PROJECT TITLE: FUELING STATION SOLID WASTE ZONE ATLAS/DRNG. FILE #: 9-15 129B
DRB #: N/A EPC #: N/A WORK ORDER #: N/A D 29B
LEGAL DESCRIPTION: G15

RE: DRAINAGE PLAN FOR SOLID WASTE MANAGEMENT DIVISION FUELING
STATION (G15-D29B) SHEET 2/16 ENGINEER'S STAMP DATED 10/8/97

RE: DRAINAGE PLAN FOR THE CITY OF ALBUQUERQUE SOLID WASTE FUELING STATION (G15-D29B)

RE: DRAINAGE PLAN FOR SOLID WASTE FUELING STATION (G15-D29B) ENGINEER'S
STAMP DATED 12/16/92.

SQUARE AND RECTANGULAR DRAINAGE GRATES

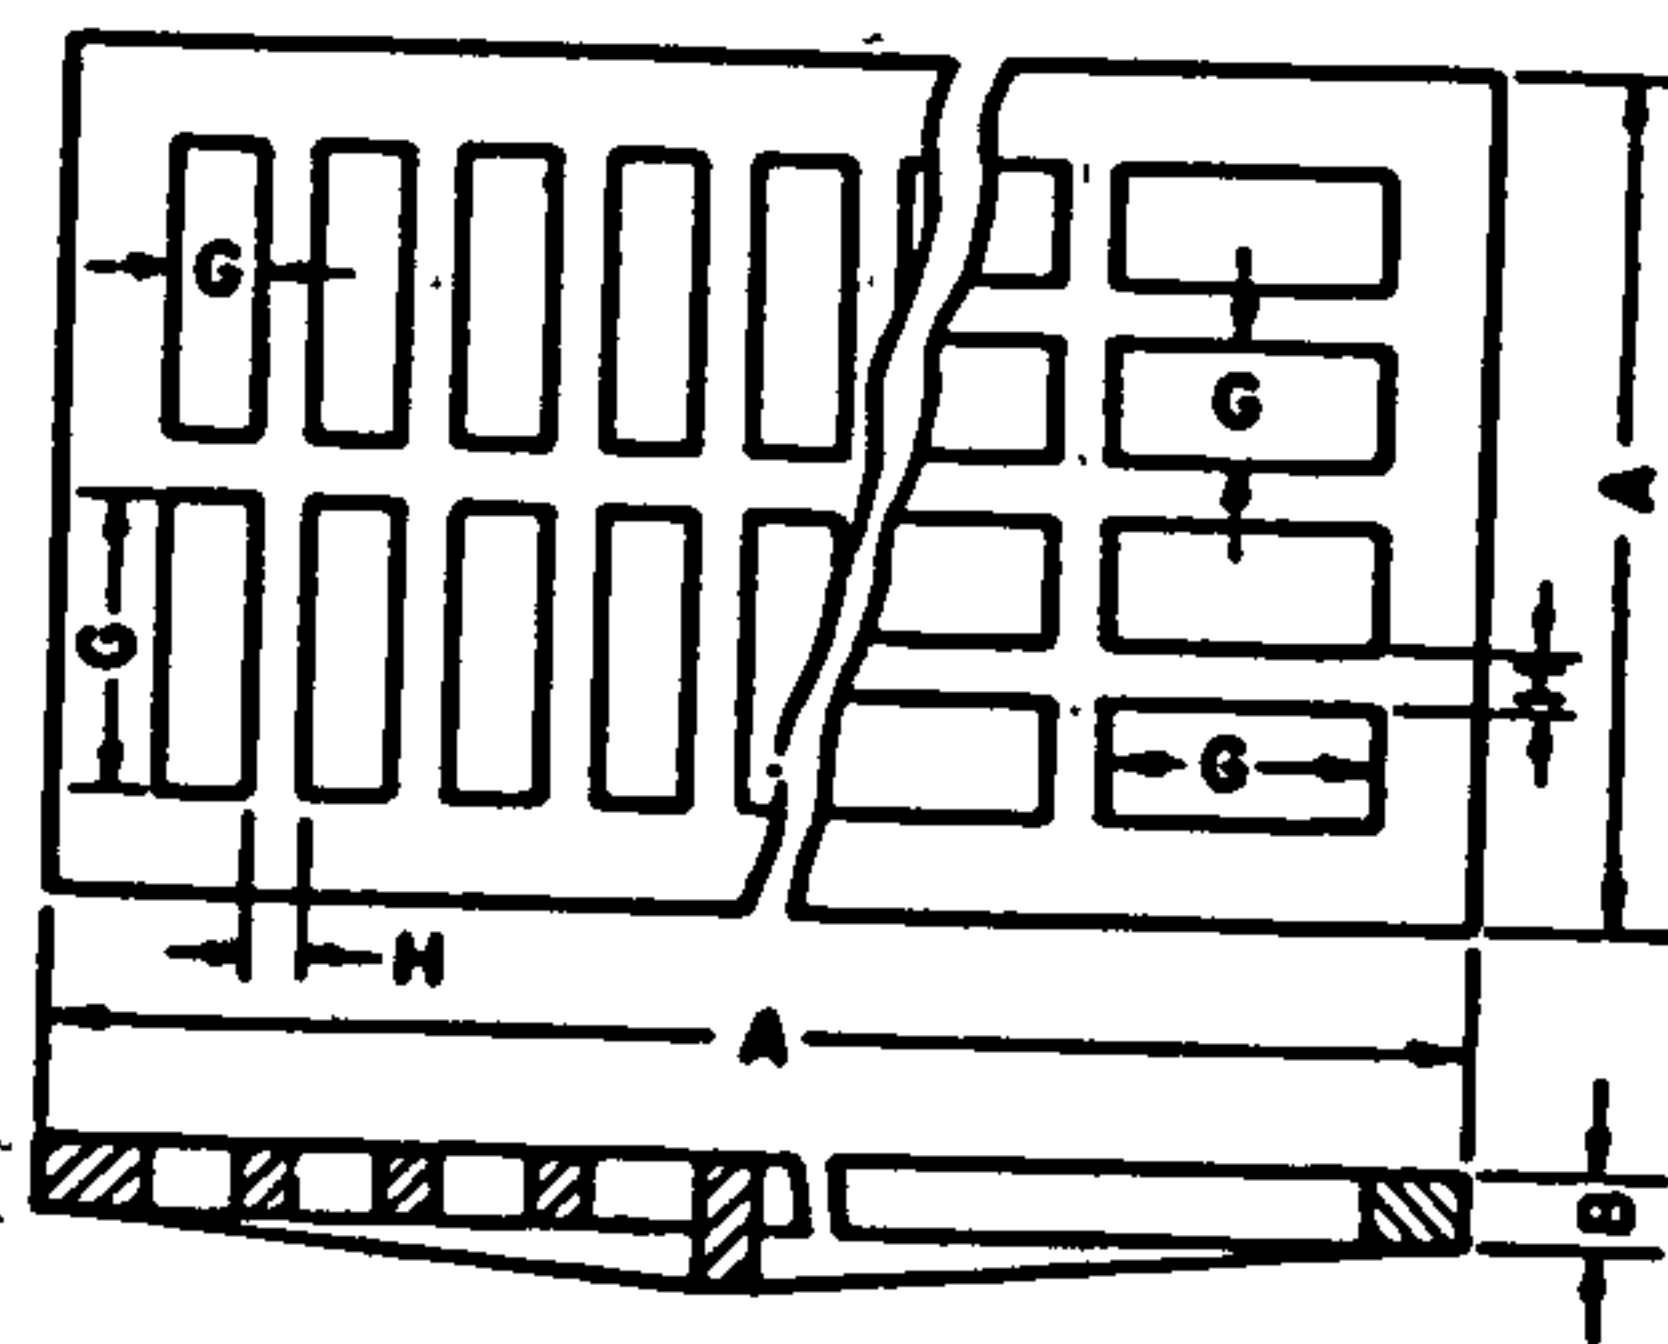
1. Please provide calculations showing the inlet capacity in a sump condition.

Neenah Grate R4552 = 0.6 ft^2 open area
R4557 = 0.8 ft^2 open area } use avg. = 0.7 ft^2

✓ The inlet capacity is 3.37 cfs as shown on the attached calculations. The peak flowrate for a 2-year storm is 0.4 cfs, so the inlet capacity exceeds the design inflow.
